# Sherwood Acres Subdivision

# **Sherwood Acres Subdivision**

## **Environmental Review Team Report**

**August 2001**

Figure 3.  
Overview Subdivision Map

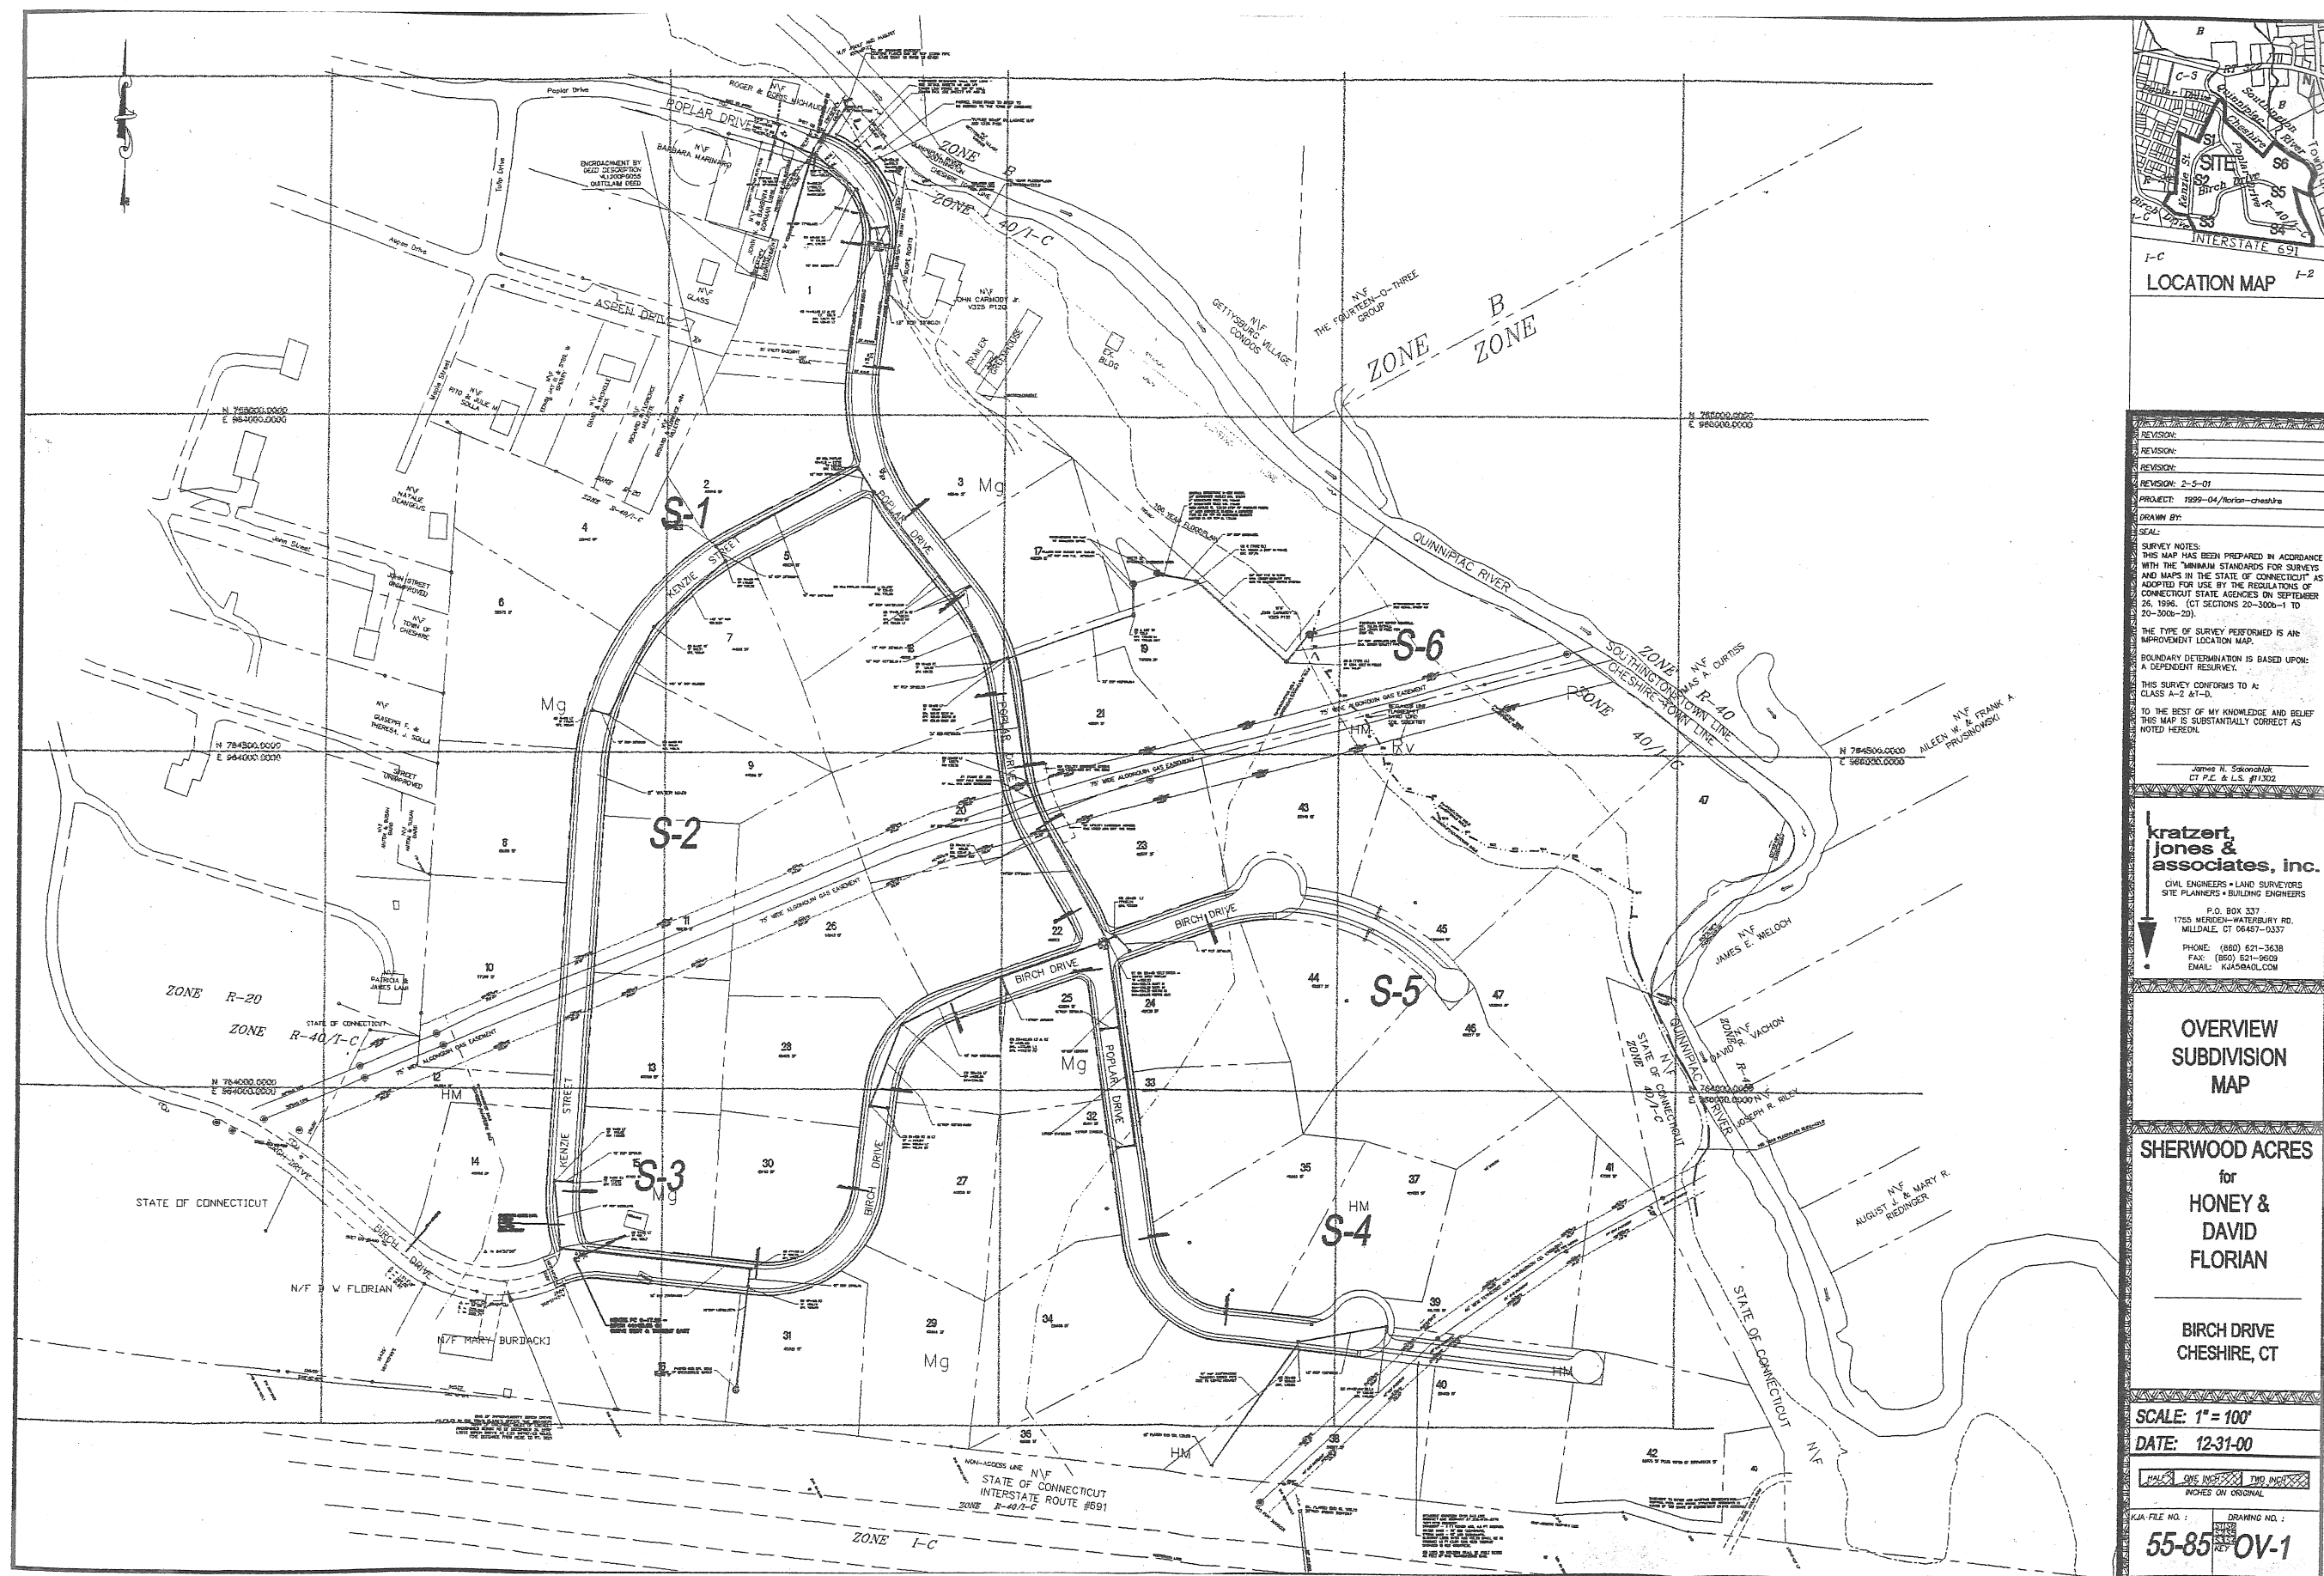
The roadways themselves seem unnecessarily wide with 30' of pavement, curbing and sidewalks on both sides. The CT DOT standard width of pavement for secondary roads is only 24' with 10' travel lanes and 2' shoulders. This subdivision comes off of side (tertiary) streets which range in width from 26' to 16', therefore the need to construct the subdivision roads wider than the streets that lead into the subdivision seems tenuous. Additionally, it is not necessary to have sidewalks on both sides of the street, or even at all, unless there is an attraction nearby such as a school, playing fields, or park. This extra pavement further increases imperviousness and decreases on-site infiltration.

Also, it may not be necessary to completely pave the interior of the cul-de-sacs. Emergency vehicles and snow removal equipment turning radii have been adequately addressed in other communities with modified cul-de-sacs designed with a depressed and pervious (unpaved) center. The center of the cul-de-sac can then serve as an effective treatment for stormwater runoff before percolating into the ground. A demonstration of this alternative design can be viewed at the Glen Brook Green Subdivision, located in the Jordan Brook sub-watershed in Waterford.

Rather than simply informing the property owner of his/her obligation to obtain a permit, it would be more prudent to place the buffer zone in conservation easement in favor of the Town of Cheshire or perhaps the local land trust by way of a deed restriction which specifically identifies what activities (if any) are to be allowed within this area. Additionally, Lot 45 has only a 60' buffer. For the sake of consistency, both for the protection of the wetlands and watercourse, and for compliance among neighbors, the 100' buffer should remain uniformly in effect which may mean omitting Lot 45 from site development.

- *Buffer/Setback* - The only inconsistency to the 100 foot wetland buffer occurred at lot 45 where the buffer was reduced to 60 feet to accommodate a structure. Subsequent to the ERT field walk, the town Wetlands Commission voted to deny lot 45 for the lack of 100 foot buffer. As mentioned above, the commission also denied lots 19 and 43 for insufficient information about the potential vernal pool at the rear (east-north-east) on lot 19.

- redesign infiltration basin to provide water quality renovation;
- select appropriate seed and mulch to quickly stabilize disturbed sites;
- increase groundwater infiltration by eliminating road curbing and allowing for sheetflow, construction of vegetated drainage swales, reducing road width, minimizing sidewalk coverage, designing cul-de-sacs with a pervious center, and promoting pervious driveways;
- placing 100' wetlands buffer in conservation easement, and omit Lot 45 if unable to maintain 100' buffer.
